### **Council Advice Regarding Modification Application - SSI-8609189 – MOD 1**

This advice relates to the proposal by Sydney Water to modify an approved wastewater processing facility known as the Upper South Creek Advanced Water Recycling Centre (**AWRC**), under MOD 1 of SSI-8609189.

**Figure 1 (above):** Excerpt from Modification Report. The proposal includes the deletion of the Environmental Flows Pipeline, related trenching, tunnelling, and release structure (pipeline to be deleted is indicated with a dark blue line).

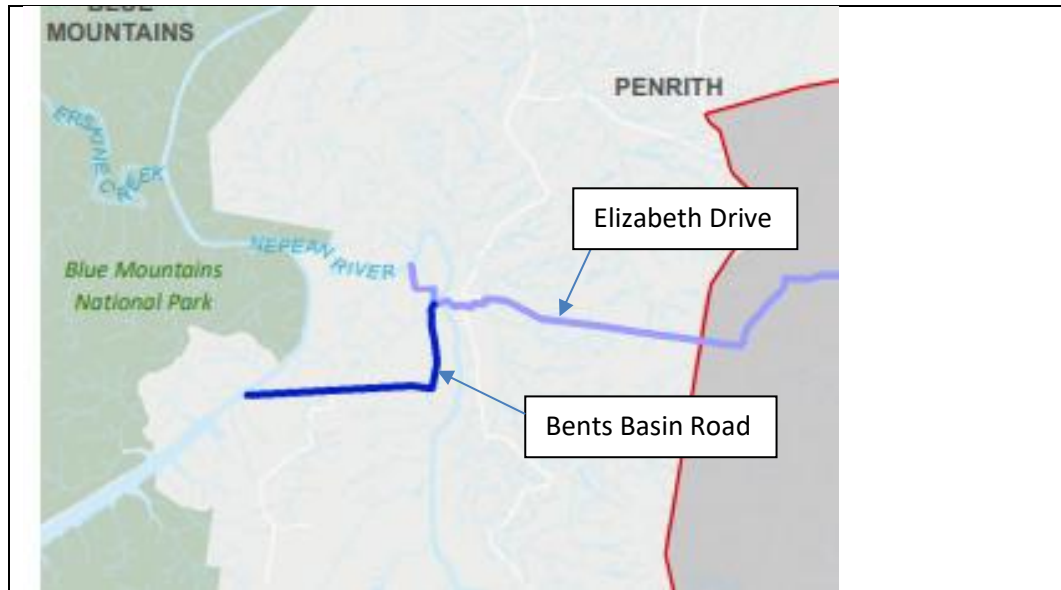
The subject modification application proposes to delete a section of pipeline within Stage 1, known as the environmental flows pipeline being a total of 4.5kms in length, including all immediately related infrastructure and civil works.

**Figure 1** below identifies the section of pipeline which will no longer form part of the approved AWRC, should the modification be supported.

Thank you for providing Council with the opportunity to comment on the modification application. Council has reviewed the documentation and raises no objections or other matters for additional consideration in the Department's assessment of the application.
